# HISTORIC AND DESIGN REVIEW COMMISSION

**HDRC CASE NO:** 2022-346  
**ADDRESS:** 506 STIEREN  
**LEGAL DESCRIPTION:** NCB 2966 (STIEREN STREET REPLAT), BLOCK 1 LOT 18  
**ZONING:** RM-4, H  
**CITY COUNCIL DIST.:** 1  
**DISTRICT:** King William Historic District  
**APPLICANT:** Caroline Gado  
**OWNER:** APOLLO MAYORAL LLC  
**TYPE OF WORK:** New construction of four, multi-story structures  
**APPLICATION RECEIVED:** June 13, 2022  
**60-DAY REVIEW:** Not applicable due to City Council Emergency Orders  
**CASE MANAGER:** Rachel Rettaliata

## REQUEST:

The applicant is requesting conceptual approval to construct four residential structures on the lot addressed 506 Stieren. The proposal includes three, 3-story structures and one, 2-story structure.

**1 UNIT 1-FLOOR PLAN- 1ST LEVEL**  
SCALE: 1/4" = 1'-0"

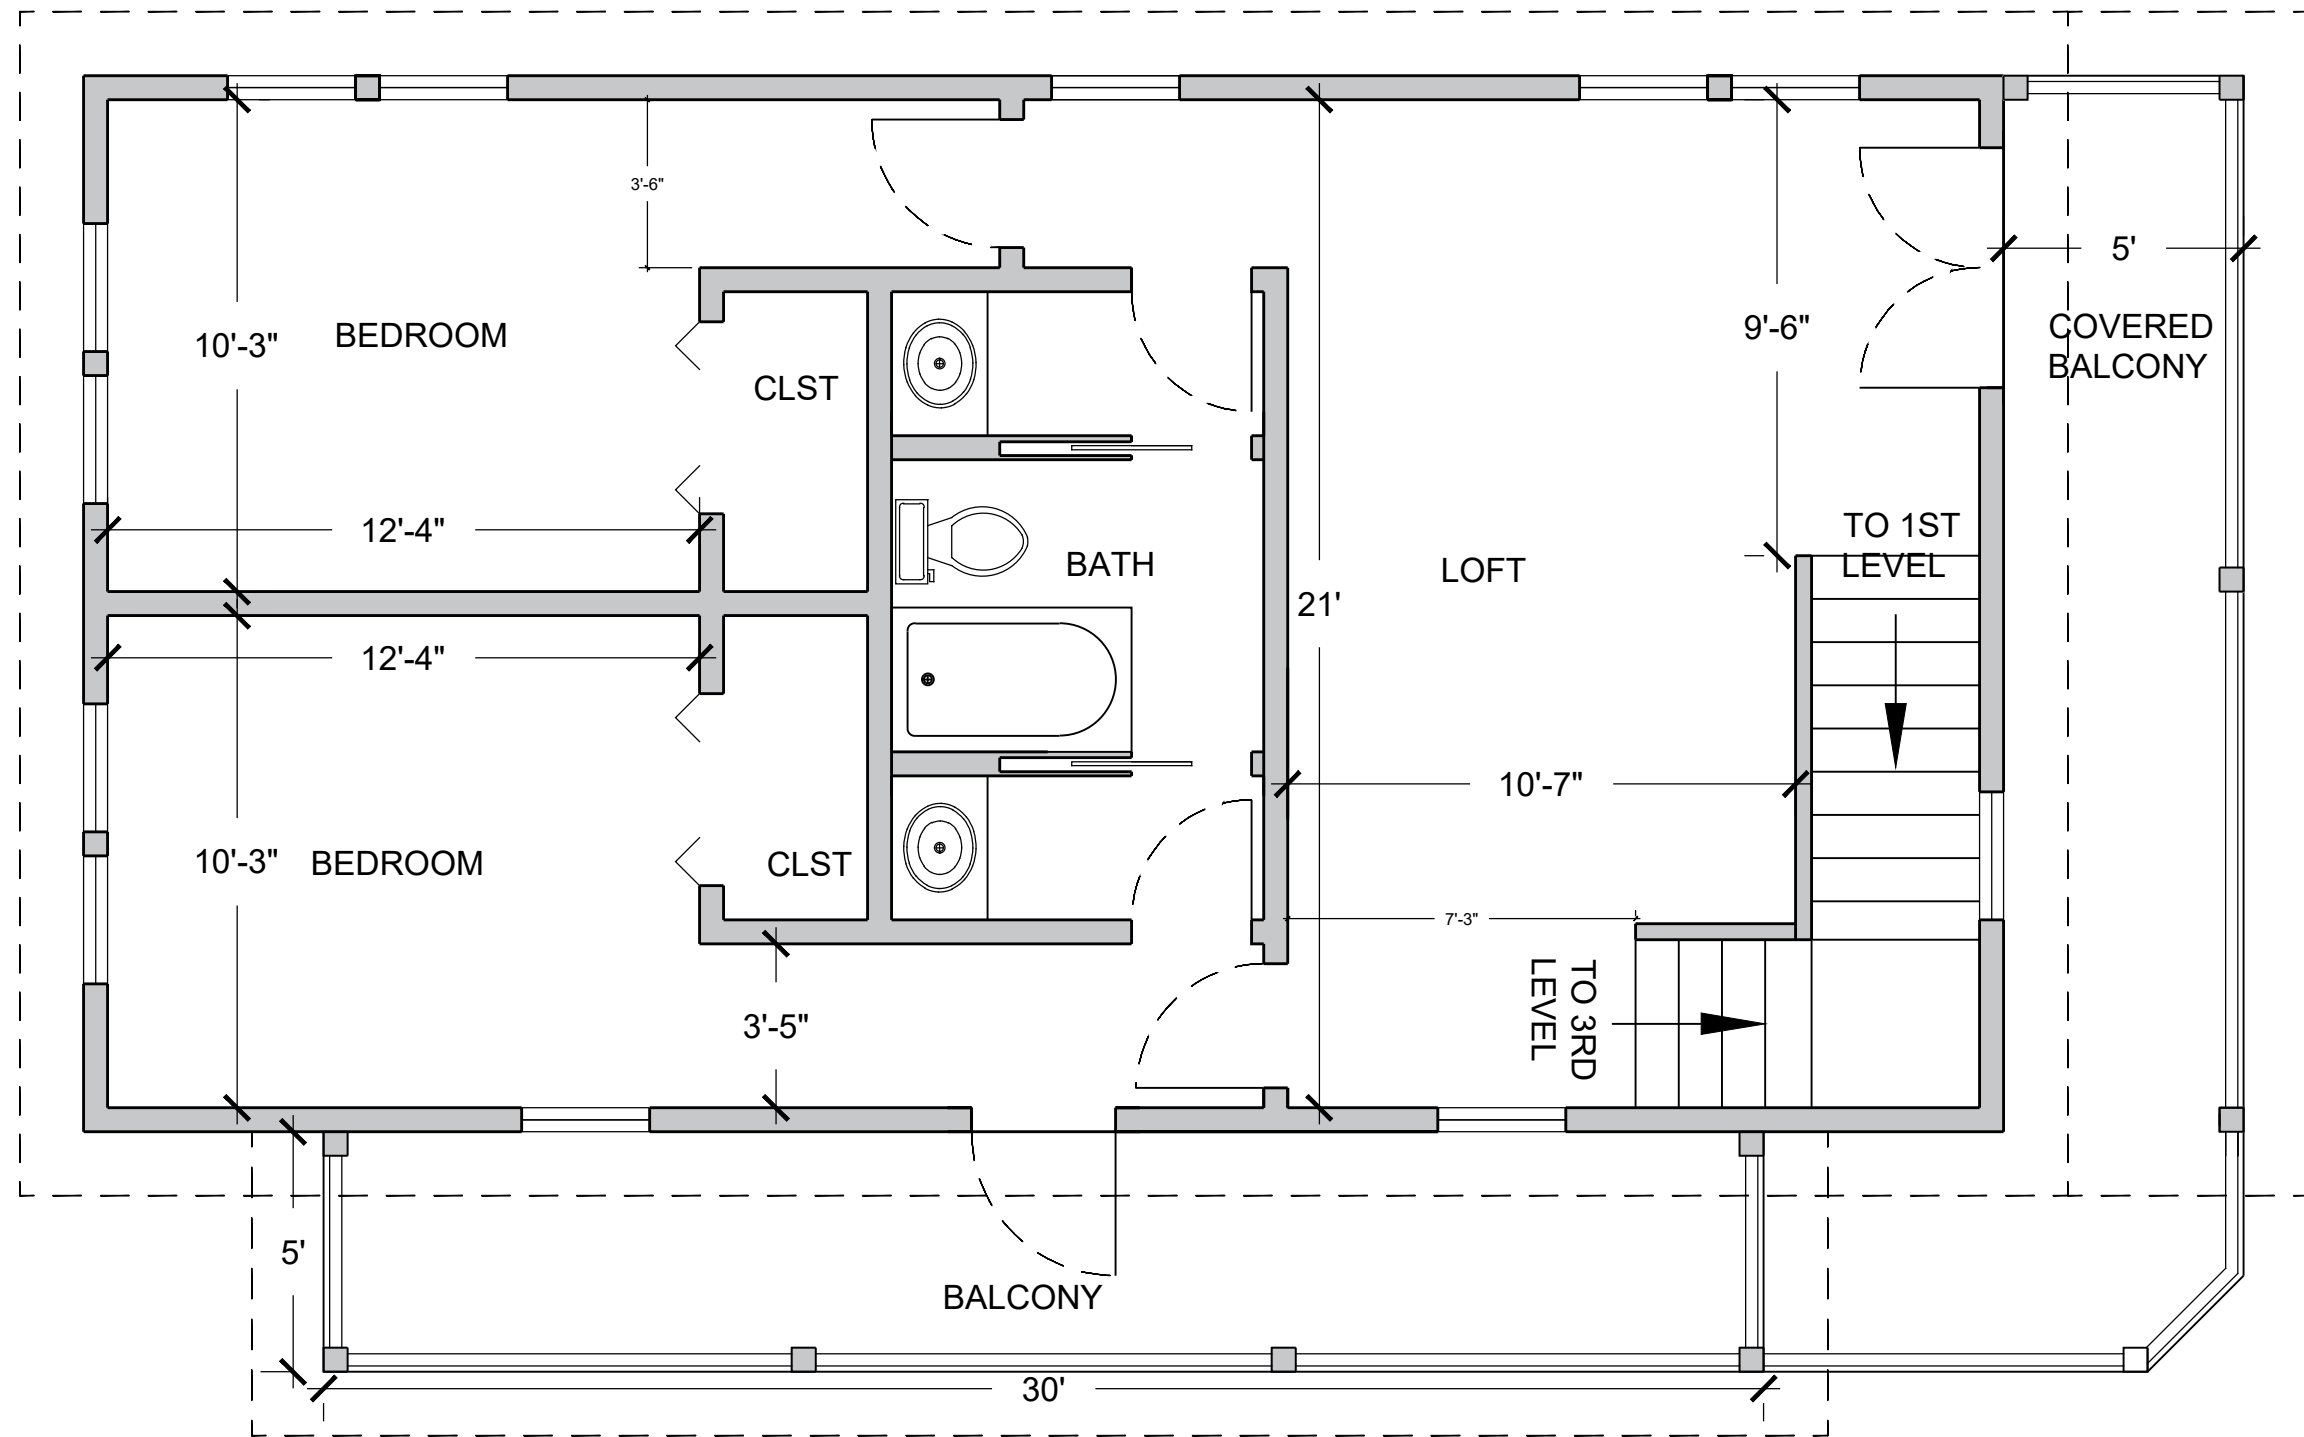
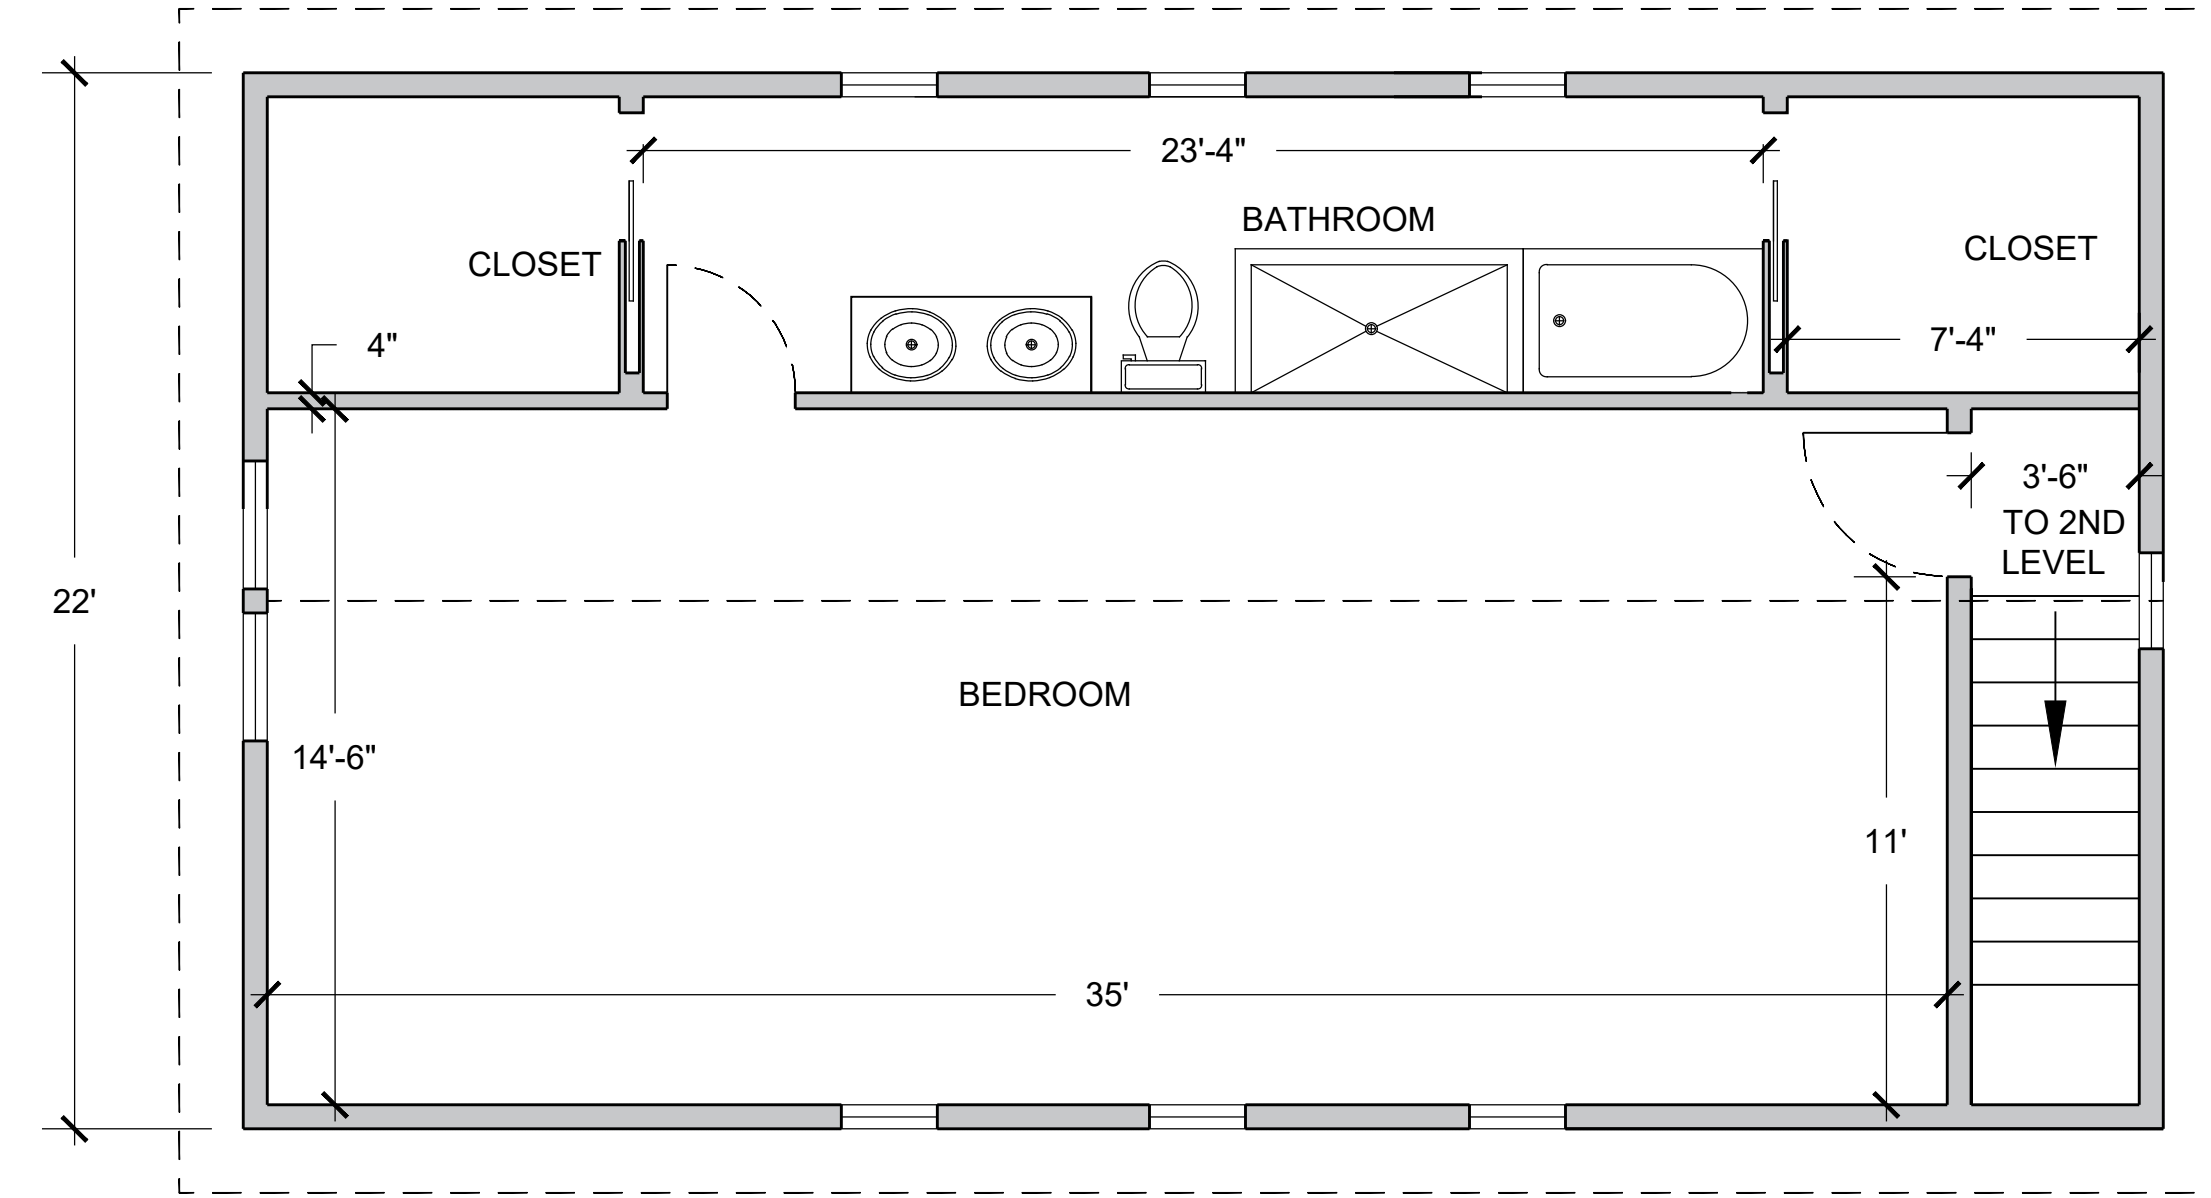
RM: I would like to echo Lisa’s comments. It is awkward having a front door open to a privacy fence.
